Title: Ward Water Treatment Plant Upgrades

Change Order No. 001

Project: Ward WTP Upgrades	Owner: The City of High Point	Owner's Contract No.: Bid #56-082218
Contract: Ward Water Plant Upgrades		Date of Contract: 18-SEP-2018
Contractor: Wharton Smith Inc.		Engineer's Project No.: 190221

ATTACHMENT A

Figure (1)

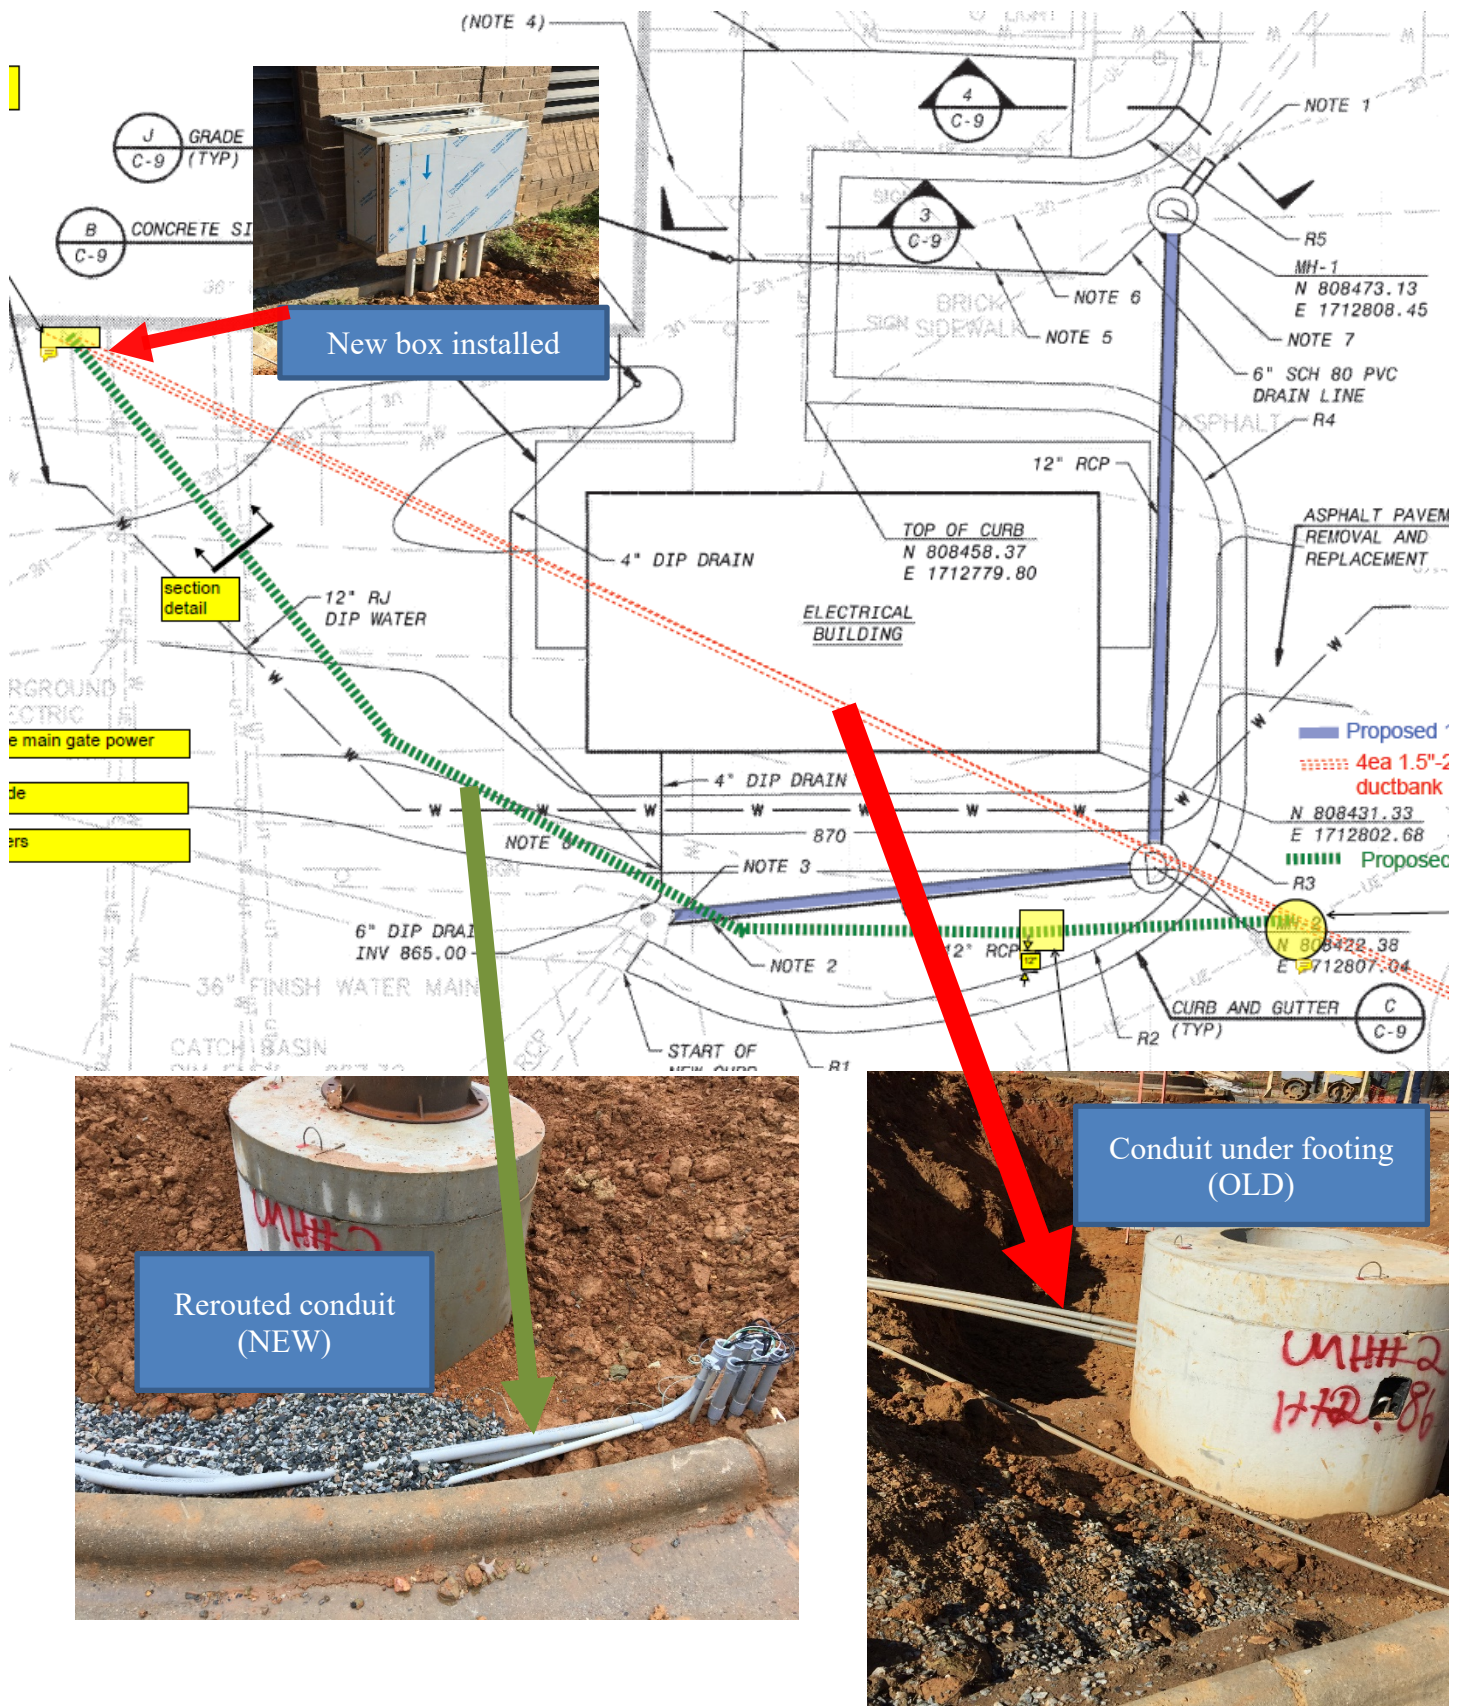
DISASSEMBLE AND REASSEMBLE 15
“VALVES AND ACTUATORS

Item #1 – Replacement of Butterfly Valves at the existing Cluster Filter Gallery for an additional cost of \$38,483.00 and a time extension of 7 calendar days.

Per a request for proposal issued by the Engineer to the Contractor in representation of the City of High Point (CHP), the scope of additional work associated to this item of the change order includes the removal and reinstallation of designated Ductile Iron Pipe (DIP) sections located inside the Cluster Filter Pipe Gallery. The intent of such removal and reinstallation was to accommodate a visual inspection by maintenance personnel from the City of High Point to evaluate the extent of deterioration and leakage of (4) existing 16” Butterfly Valves, as well as the installation of new Owner furnished Butterfly Valves if needed. This additional task performed by the Contractor also included the installation of cribbing/rigging to secure and support the existing piping network inside the Pipe Gallery during disassembly/reassembly, as well as the use of temporary blind flanges and hardware, copper piping/fittings, PVC piping/fittings, hydraulic jacks, and dewatering pumps to safely secure the area during the performance of the work.

Figure (3)

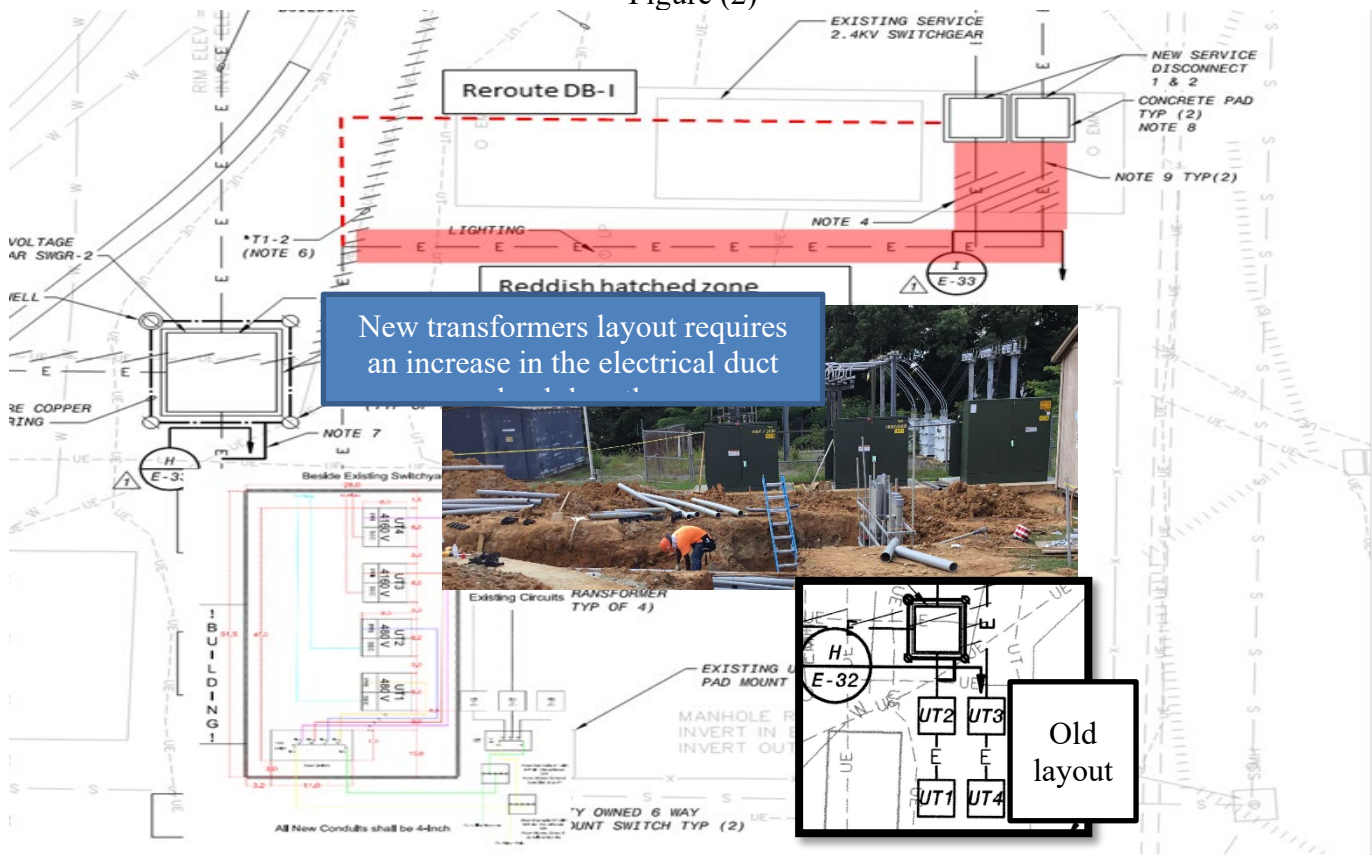
Item #6 – Installation of additional underground duct bank from new Switchgear #2 to the new Low and Medium Voltage Transformers due to Switchyard modification by the City of High Point Utility for an additional cost of \$76,752.00 and a time extension of 13 calendar days.

During the course of construction, the City of High Point Utility (CHP Utility) provided notice the all project related parties about a rearrangement of the switchyard layout housing the new 4160V/480V transformers (4 transformers total). Per the requirements of the Contract Documents, these 4 transformers are to be furnished and installed by the CHP Utility. These modifications required by the CHP Utility altered the original design layout depicted in Drawing E-4 “*Enlarged Site Plan I*”, requiring from the Contractor to extend further the underground Duct Banks “H” coming from Switchgear #2 to the new transformers, as well as Duct Bank “I” coming from the new transformers to the new Service Disconnects #1 and #2, respectively.

The scope of work associated to this item of the change order included additional trench excavation, the installation of new 5” and 4” Schedule 40 PVC conduits with associated fittings and high-impact spacers and support systems, the wiring of #500, #350 and #4/0 XHHW CU stranded wire conductors, and the placement of 3,000 psi concrete encasement to protect the extended underground duct bank, as well as the required additional backfilling, detectable tape and soil stabilization to finish grade.
